**From:** Clinton M <muggec1@gmail.com>  
**Sent:** Friday, December 6, 2024 12:25 PM  
**To:** Melissa Jenck  
**Subject:** EXTERNAL: FW: Neskowin Plat\_5S11W35\_Lot214 FireDept Summary

**From:** Clinton Mugge <muggec1@gmail.com>  
**Date:** Thursday, January 25, 2024 at 4:02 PM  
**To:** Jim Oeder <joeder@nrfd.com>  
**Cc:** Michelle Mugge <michelle.mugge@gmail.com>  
**Subject:** Neskowin Plat\_5S11W35\_Lot214 FireDept Summary

**MUGGE HOUSE**

SITE PLAN 1" = 30'

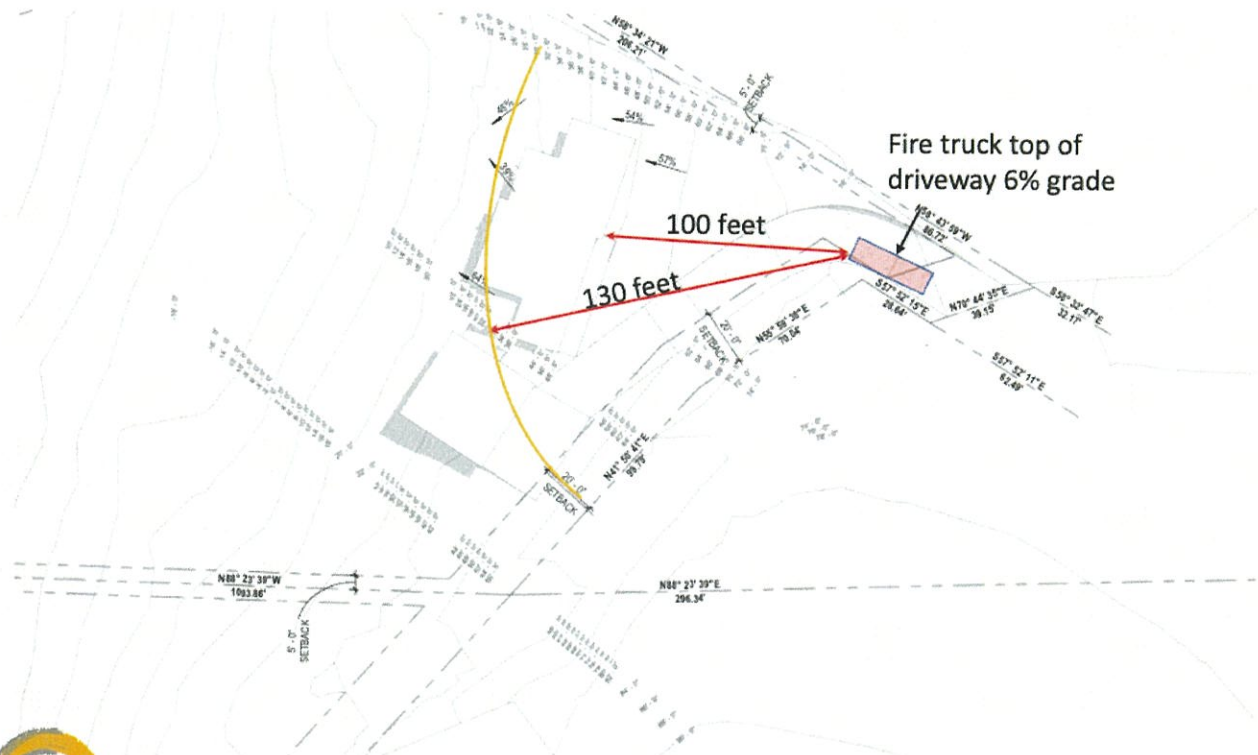
Greetings, and thank you again for meeting us on 1/11 to look at the property in Neskowin, we really do appreciate you took the time out of your day. Per your feedback we will develop plans based on using our driveway to provide fire service which should meet the code guidelines and or address concerns to provide fire services.

1. We are going to the top of the driveway for providing fire service access. The distance will put the front of the home within 100 feet at the top of the drive, and incorporate a grade at the entrance to less than 6% (bring us within Oregon Fire Code Appendix D distance and grades). That places firetruck parking just above the house (see illustration for location and distances).
2. The driveway at the top going to our house will be 18 feet wide for the truck parking and movement around it for the fire crew.
3. We will ensure the road to the property (southbeach) meets code to include cleaned up and improved at the driveway entrance and exit.
